Item Name: 205 Skidtube bent detail

DRAWING NO. D2580	TITLE 205 SKIDTUBE ASSEMBLY	REV. E	DART AEROSPACE LTD ENGINEERING ORDER	D.E.O. NO. D2580-E-1	SHEET NO. SHEET 1 OF 1	SCALE NTS
DRAWN <i>UP</i>	CHECKED <i>ASS</i>	MFG. APPR. <i>EC</i>	APPROVED <i>HA</i>	DE APPR. <i>HA</i>		
DATE 11.12.13	DATE 11.12.13	DATE 11.12.13	DATE 11.12.13	DATE 11.12.13	DATE 11.12.13

CHANGE ALL C'BORED WELDED CROSSBOLT SPACERS TO SWAGED SPACERS

SECTION B-B, F-F, I-I
NOT TO SCALE

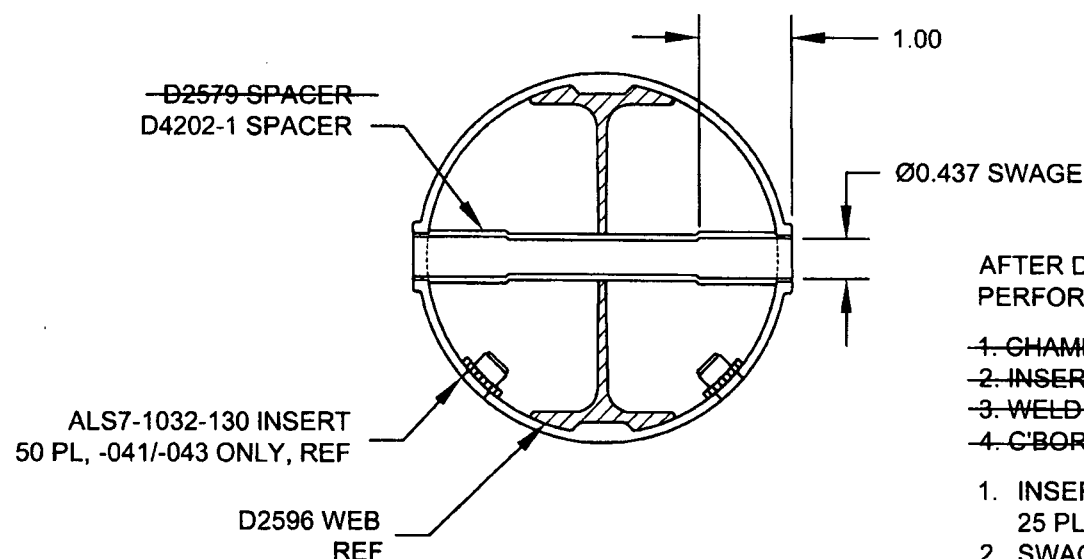
SECTION B-B, SECTION F-F, & SECTION I-I ARE AMENDED AS FOLLOWS
FOR ALL HOLES THAT WERE ORIGINALLY C'BORED:

AFTER DRILLING AND BENDING ASSEMBLY
PERFORM THE FOLLOWING FOR Ø0.508 HOLES ONLY:

1. CHAMFER HOLE 0.050 X 45°
2. INSERT D2579 SPACER (20 PLACES)
3. WELD INTO PLACE AND GRIND FLUSH
4. C'BORE D2579 SPACER TO Ø0.437 X 1.00 DEEP

WELD 4X D2579 SPACERS PER DWG
IN LOCATIONS MARKED "NO C'BORE".
REF SHEET 4 OF DWG.

1. INSERT D4202-1 SPACER, 20 PL (-041) OR 20 PL (-045) OR 25 PL (-047)
2. SWAGE TO Ø0.437 X 1.00 DEEP PER QSI 002
3. TRIM / GRIND FLUSH PER QSI 002
